Congress of the United States
House of Representatives

January 28, 2019

I write today to provide the U.S. Army Corps of Engineers with information about water levels of the Savannah River at the Jefferson Davis Bridge, also known as the 5th Street Bridge, at the time of the signing of the Water Infrastructure Improvements for the Nation (WIIN) Act of 2016.

USGS 02196670 SAVANNAH RIVER JEFFERSON DAVIS BR, AT AUGUSTA, GA

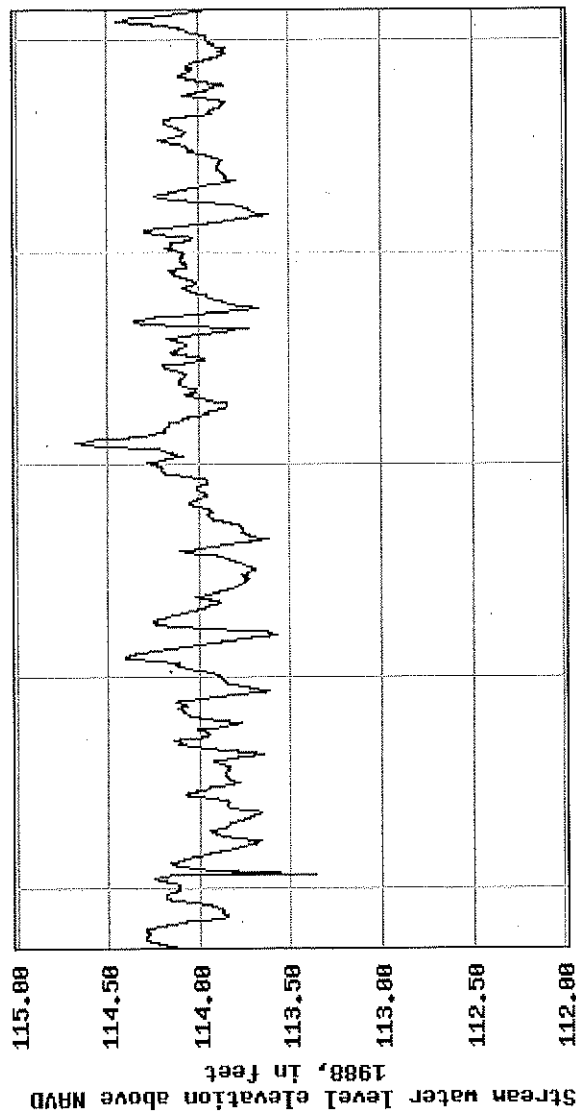
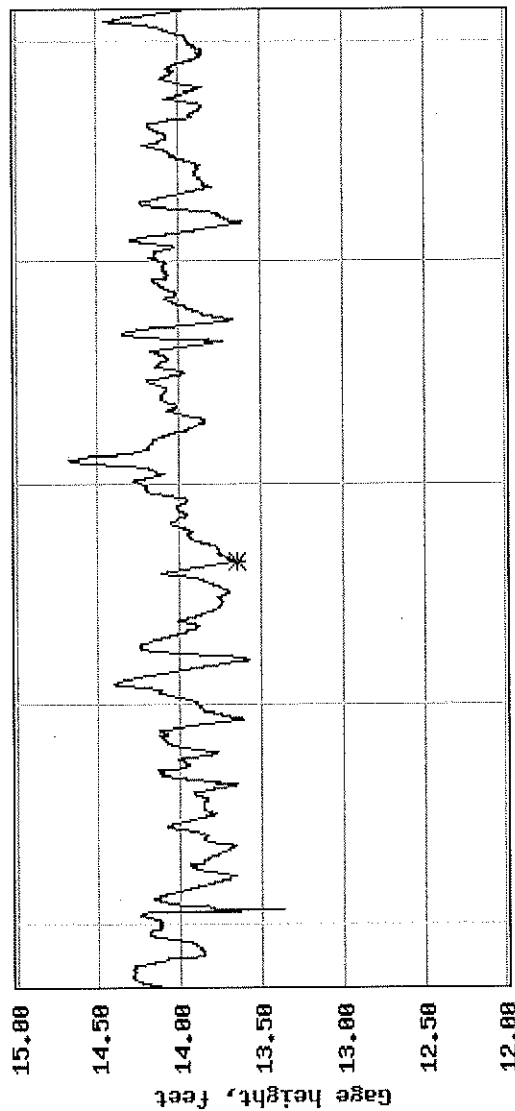
Based on the information from the U.S. Geological Survey, the water level of the Savannah River at the 5th Street Bridge varied between approximately 113.5 feet and 114.5 feet, with the gage height measuring between approximately 13.5 feet and almost 15 feet, in December of 2016, when the WIIN Act was signed into law. It was Congress’ intent that when using the language “as in existence on the date of enactment of this Act,” the water levels on that date should be the marker for what is acceptable when it comes to maintaining the pool level.

Lowering the pool is unacceptable. The language of the WIIN Act clearly states that the water level should be maintained to the level on the date of enactment of this Act, and these numbers provided by the U.S. Geological Survey clearly show that the Draft Recommended Plan does not meet the letter of the law. We respectfully request that you review the enclosed attachments and provide a response to the following questions:
